AMENDMENT TO LEASE 5574.1  
GENERAL LEASE - INDUSTRIAL USE

Project Title: Chevron El Segundo Groin and County Outfall  
Extension

MITIGATION \*

\* Prepared in response to comments on the "Initial Study, El Segundo Marine Terminal (ESMT) Protection Project, El Segundo Refinery, For Chevron U.S.A., Inc.", by Dames and Moore, March 1, 1983.

FIGURE 9

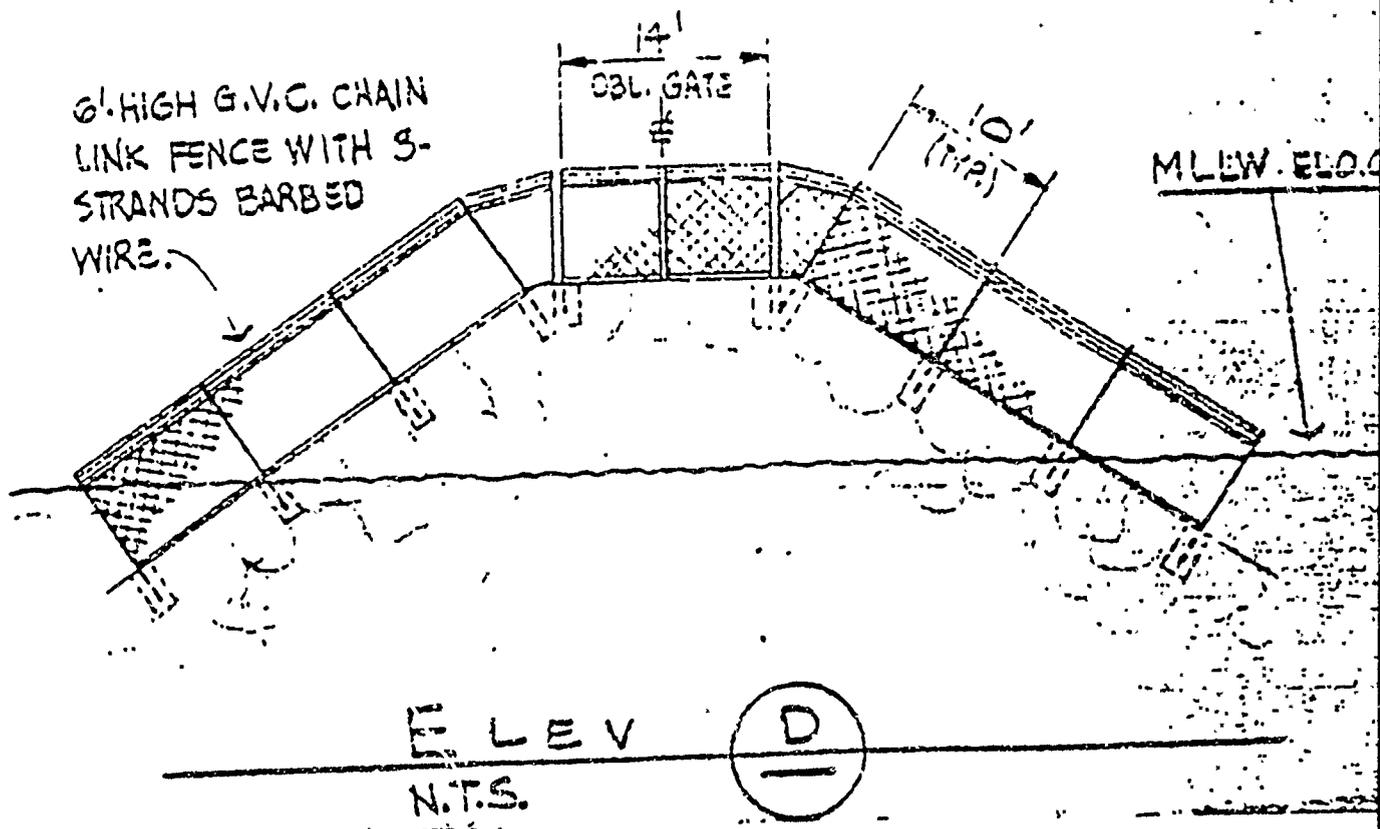
It was pointed out that the groin will constitute an "attractive hazard" if there is access to the structure by the public, and that maintenance and liability responsibilities should be clearly specified. Chevron is constructing a privately-owned structure specifically to protect their own private property being threatened by ocean erosion. As such, it is in Chevron's interest and is their intent to maintain the groin so that it continues to perform its intended function. To minimize the "attractive hazard" aspects of the structure, a 6-foot high chain link fence will be constructed approximately mid-way in the length of the groin to minimize the possibility of access to parts of the groin adjacent to and in contact with the sea. In addition, a guard rail and chain will be located at the shoreward end of the groin to prevent bicyclists from gaining easy access to the top of the groin. These two security structures are shown in attached Figures 9 and 10. Chevron will assume liability for construction and maintenance of the groin, and will provide the County and/or State with documentation releasing them from any such liability.

CHAIN-LINK FENCE TO BE LOCATED APPROX. 50 FT. OFFSHORE OF NORTH SIDE OF ROCK GROIN
